SUBJECT: Addendum No. 4

REFERENCE: Invitation To Bid (ITB) for the IAH Runway 9-27 Grind and Groove at George Bush Intercontinental Airport (IAH); Solicitation No. H06-IAHRWY-2025-009; Project No. 1073

IAH Runway 9-27 Grind and Groove at George Bush Intercontinental Airport

GEORGE BUSH INTERCONTINENTAL AIRPORT (IAH)
RUNWAY 9-27 GRIND & GROOVE
CONSTRUCTION SAFETY PHASING PLAN

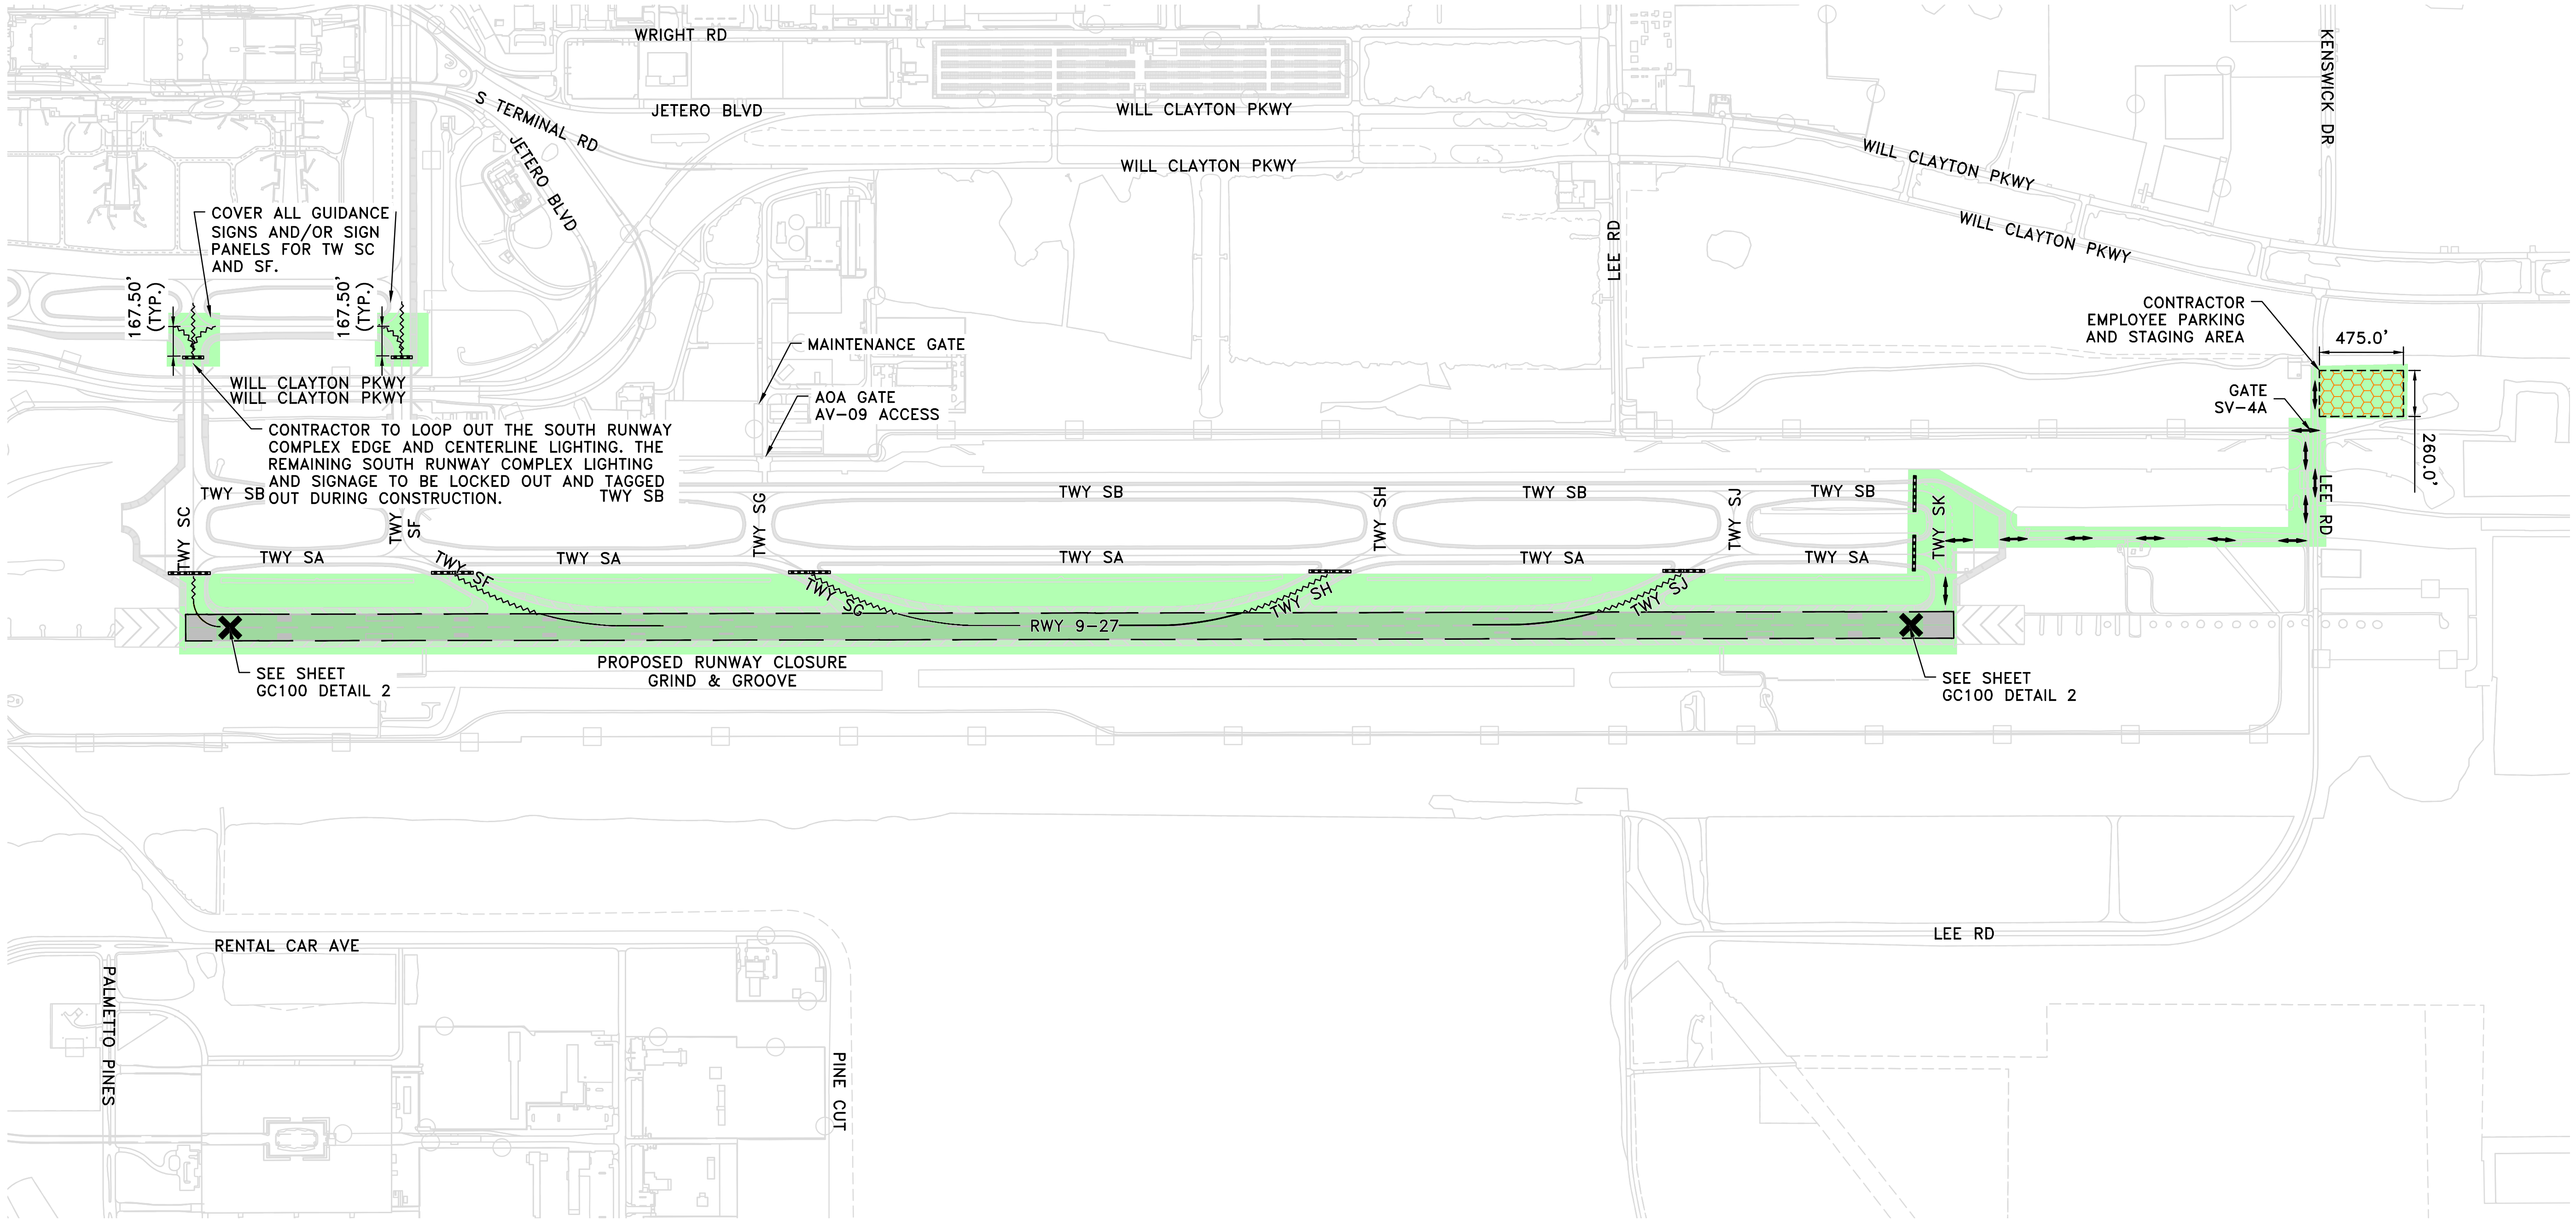
15. **Question:** Page GC-201 of the plans shows post-grind profile testing to take place after the grooving. Can this be corrected to indicate that all testing and regrinding must be completed prior to the grooving?

Response: See updated sheet GC-201 attached.

GEORGE BUSH INTERCONTINENTAL AIRPORT (IAH)
RUNWAY 9-27 GRIND & GROOVE
PROPOSED GRIND AND GROOVE PLAN
SHEET 01 OF 05

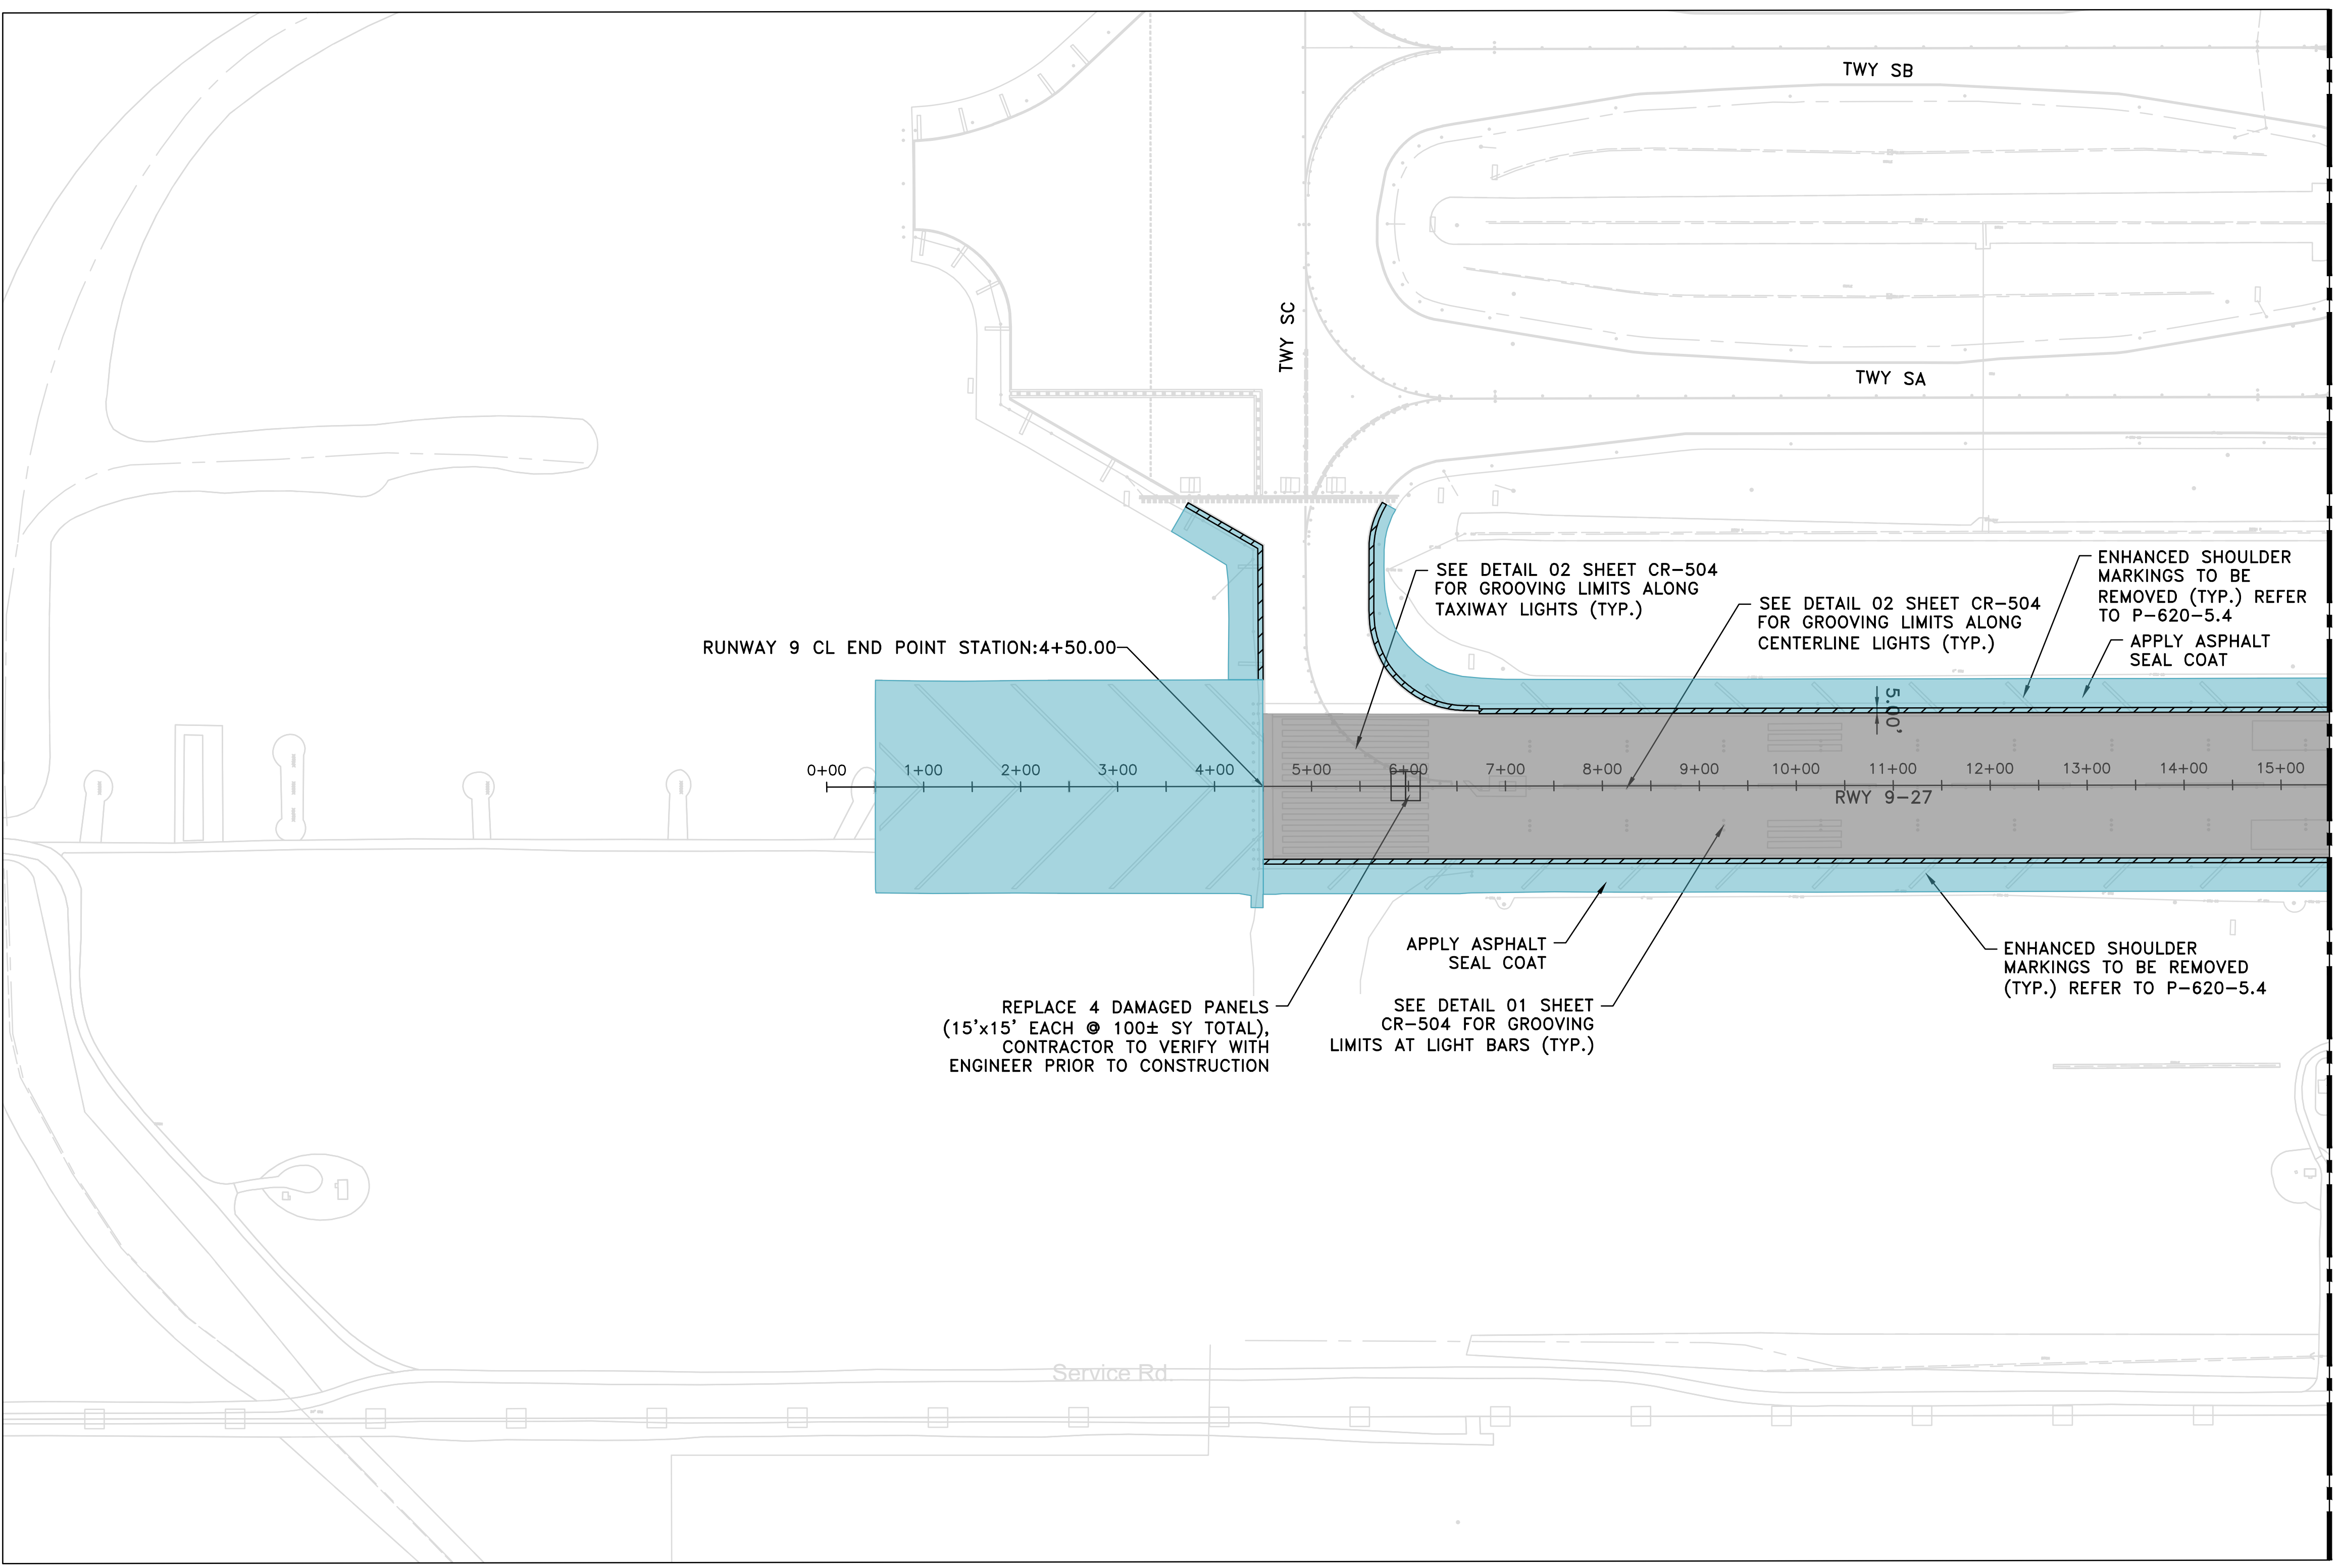
8. **Question:** Plans says 5 ft mill and pave but pay item is asphalt grinding (item# P101-4). Is this asphalt diamond grinding or regular milling? Please clarify.

11. **Question:** The plans show a 5' mill & pave item to be performed. At the pre-bid, it was said that this is Grinding of the asphalt shoulder to assist with drainage. Milling and grinding are completely different operations. Can this be clarified? If it is a mill & pave, can a line item be provided for this work?

Response: See attached G-002 and Document 00410 for quantity updates. See attached CP series for the legend update for clarification.

Response: See attached CP Series for the Legend update for clarification.
